2018 Project Review Sheet (2019 Construction)

Project #	18-604
Project Title:	Crossing Improvements at Leary & 41st
Location:	Leary & 41st

SDOT Project Summary

Figure 1: Proposed Improvement, NW 40th Street & Leary Way NW

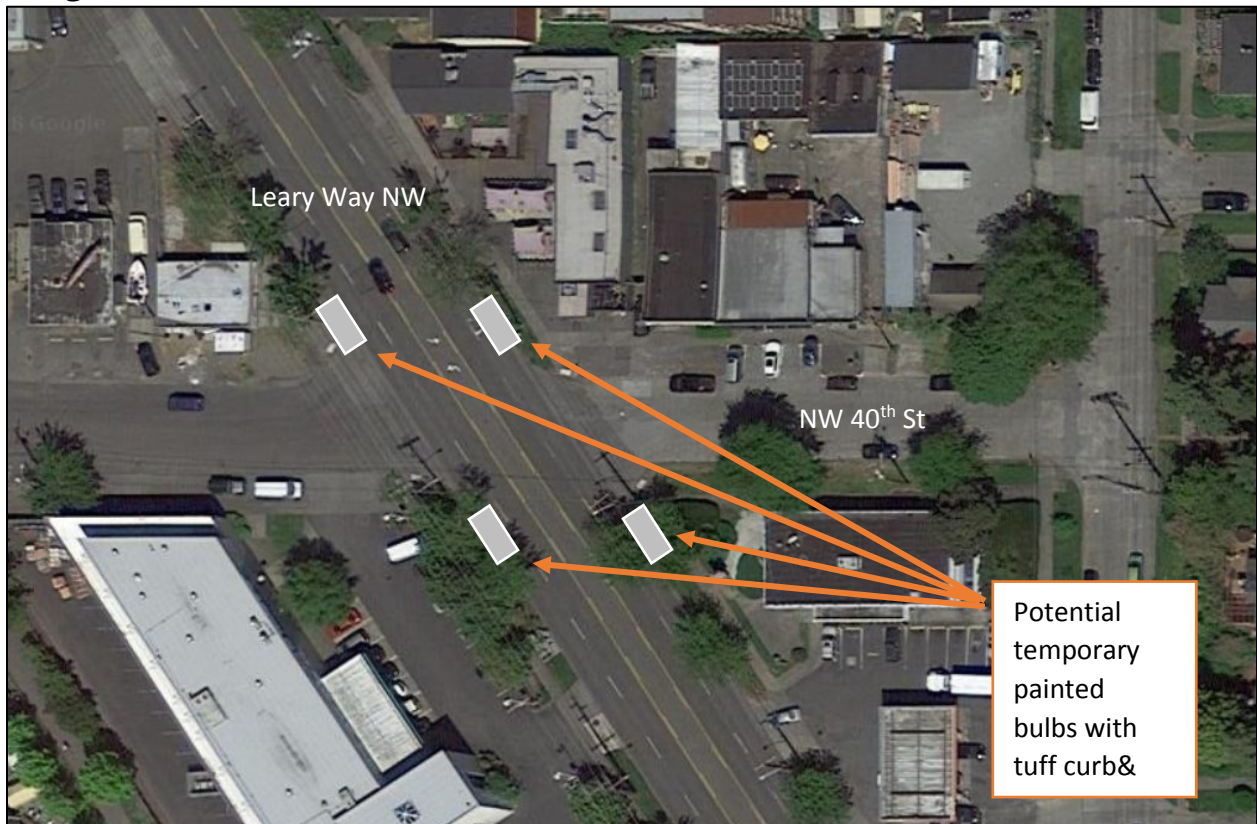
The low pedestrian counts do not warrant a new marked crosswalk across both

We have also reviewed potentially installing new center median refuge islands in the center of Leary Way NW. Due to the following:

A center median refuge island is not an option and is NOT approved.

We have also reviewed potentially installing temporary painted bulbs with tuff curb& posts along the curb line of Leary Way NW to reduce the pedestrian crossing distance across Leary Way NW.

SDOT would support the **installation of temporary painted bulbs with tuff curb & posts along the curb line of Leary Way NW** since it will reduce the crossing distance but will have a NO detrimental impact on the potential [future 2024 Seattle Rapid Ride Network: Fremont](#) corridor improvements
